FOR: HVAC Replacement
FFA Leadership Center Recreation Hall
Kentucky Department of Education
Hardinsburg, Kentucky

ADDENDUM NO. One (1)

ADDENDUM NO. 1

TO: All Plan Holders
FROM: Studio Kremer Architects
PROJECT: Future Farmers of America Leadership Camp
RECREATION BUILDING
ska# 2023-33.7

- TAGGED NOTES:**
- FIRE ALARM CONTROL PANEL WITH INTEGRAL MICROPHONE. PROVIDE NEMA ENCLOSURE WITH LOCKABLE COVER.
 - COMMUNICATIONS LINE TO MDF.
 - REMOTE ANNUNCIATOR PANEL WITH INTEGRAL MICROPHONE.

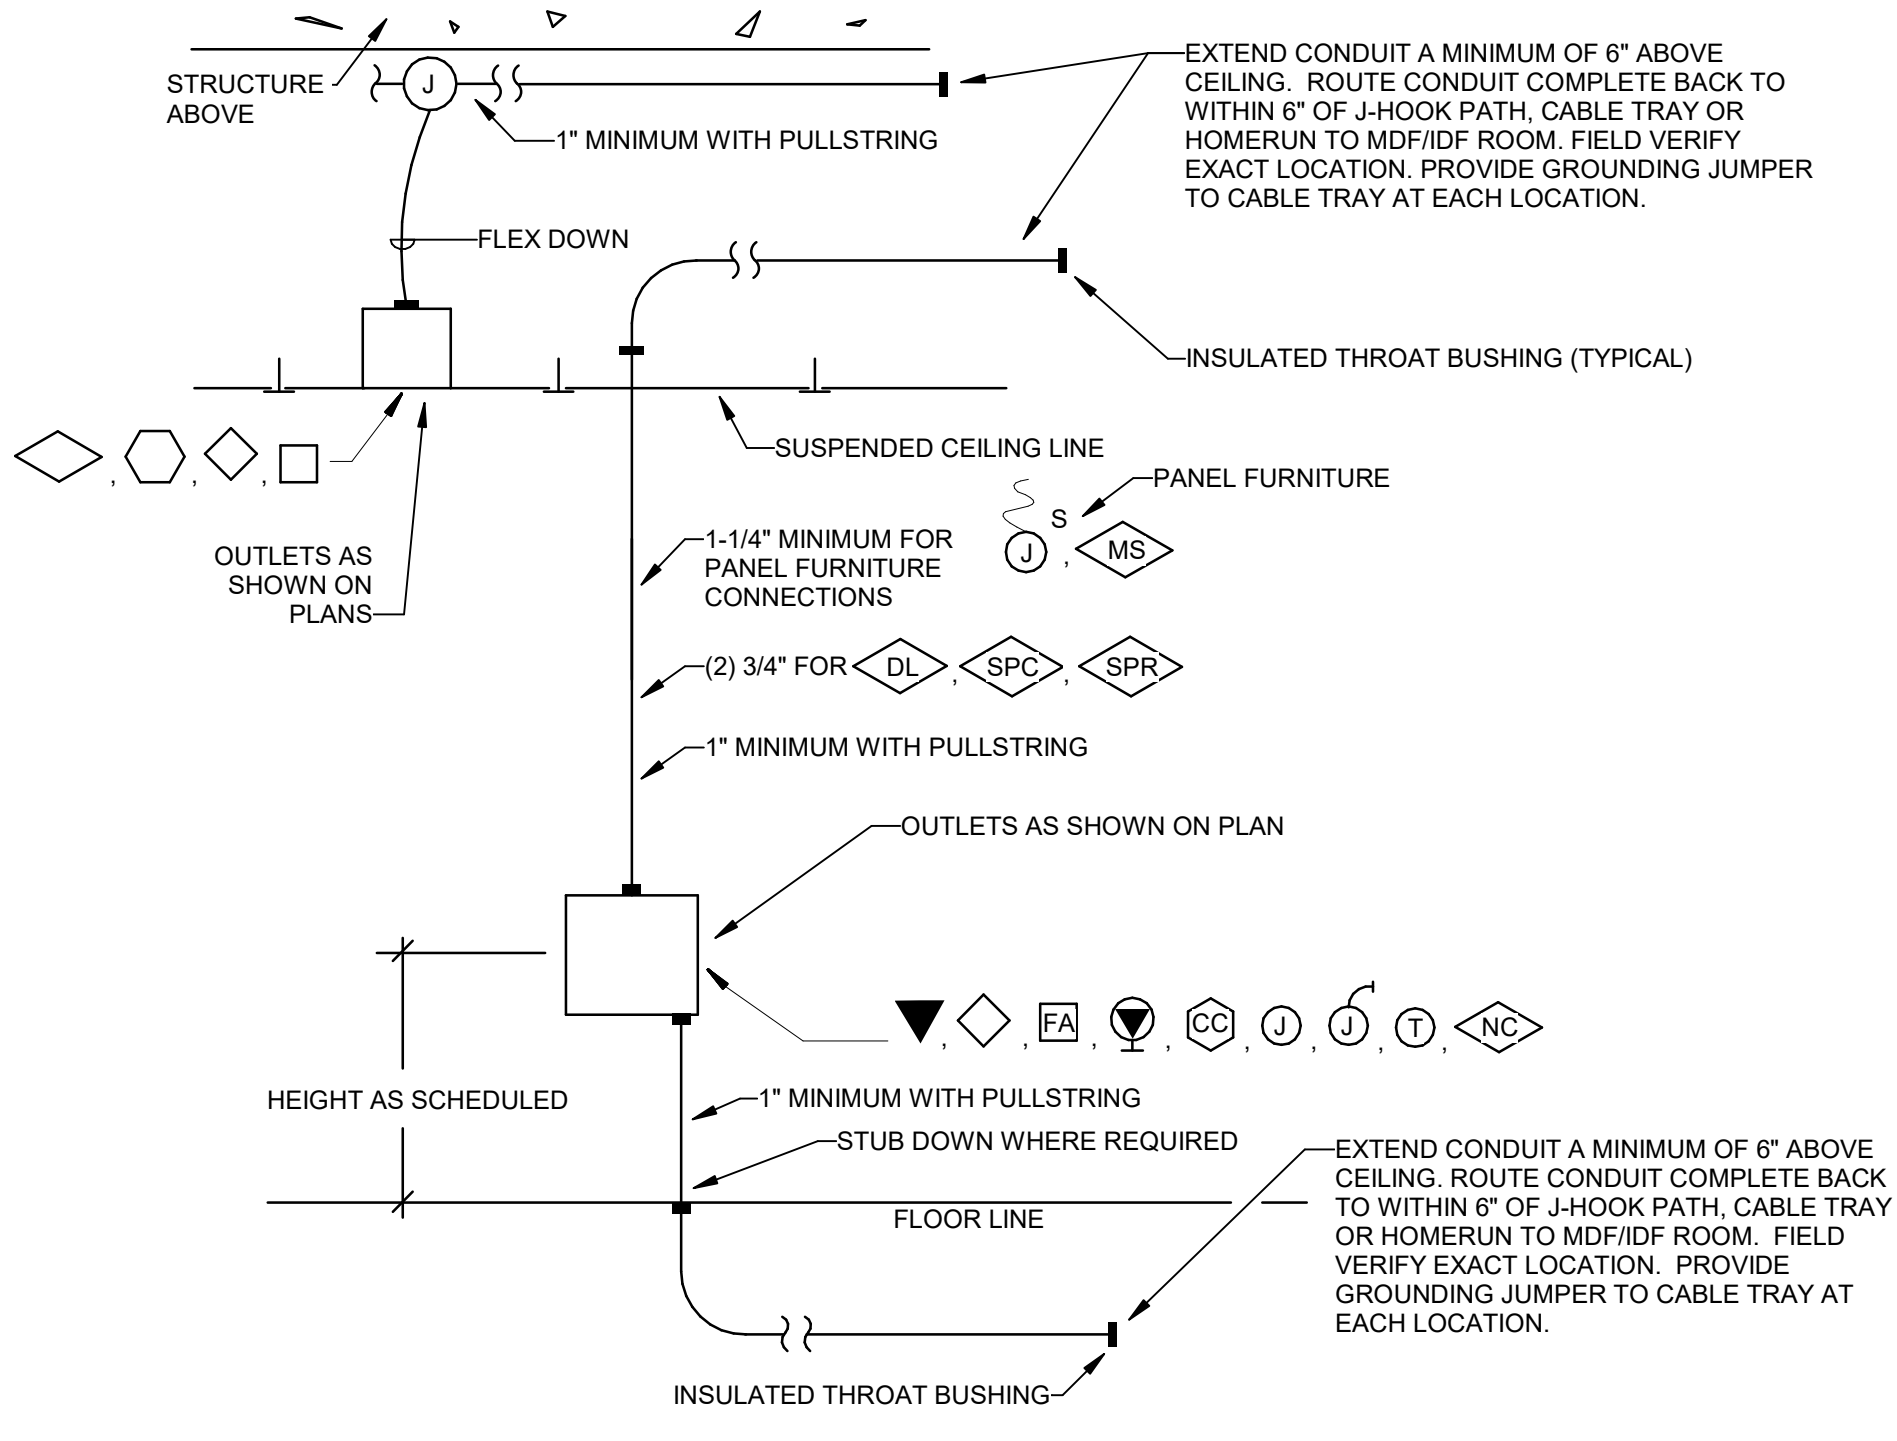
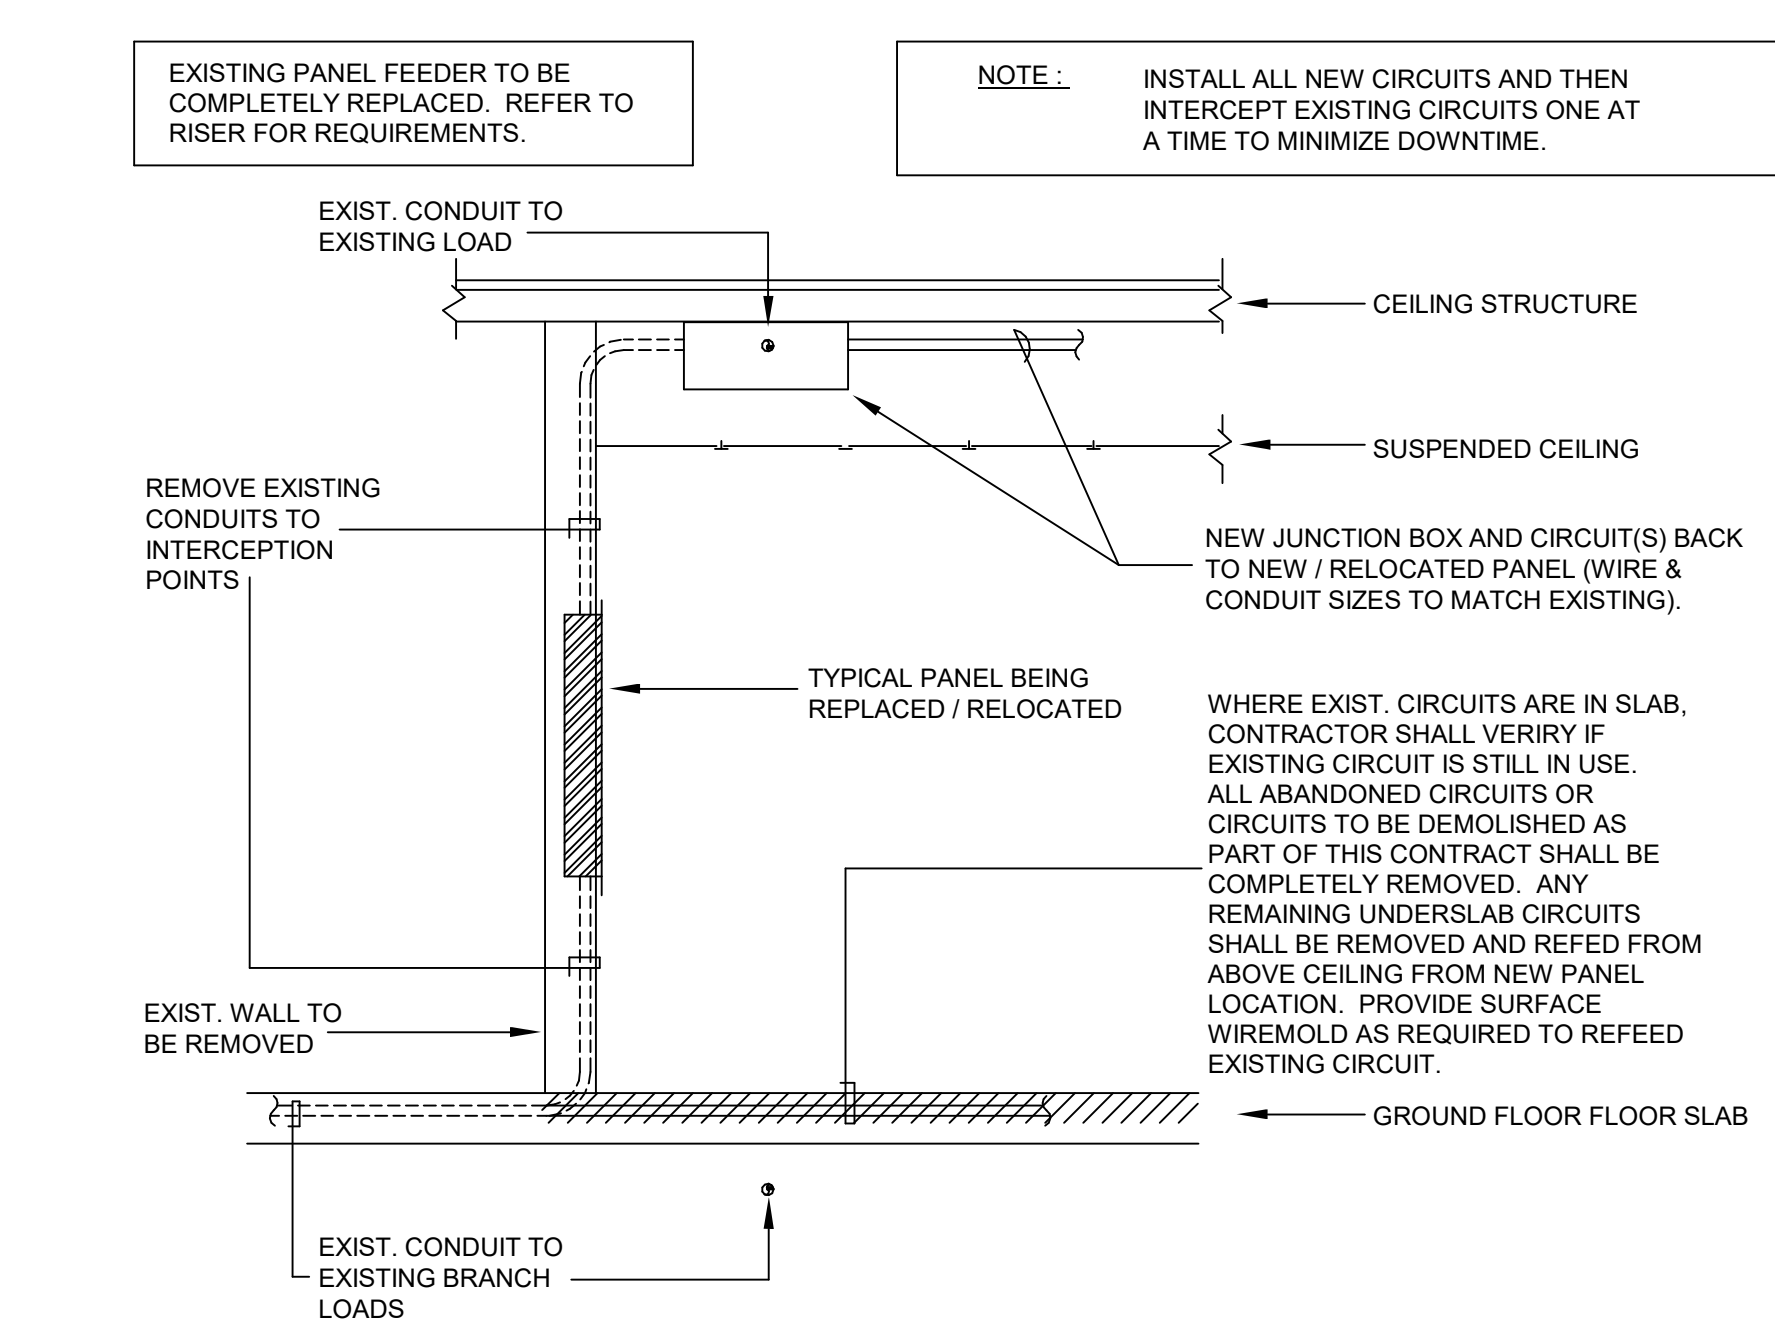
Sheet E-301

CMTA Response: 42".

CMTA Response: underground conduit shall be schedule 80.

CMTA Response: Conduit on the exterior of the building shall be Rigid Conduit. Panel P7 is located on the surface sch 80 pvc can be utilized when turning into panel p7.

CMTA Response: Yes the breaker will fit.

CMTA Response: Yes concrete encase conduits is not required.
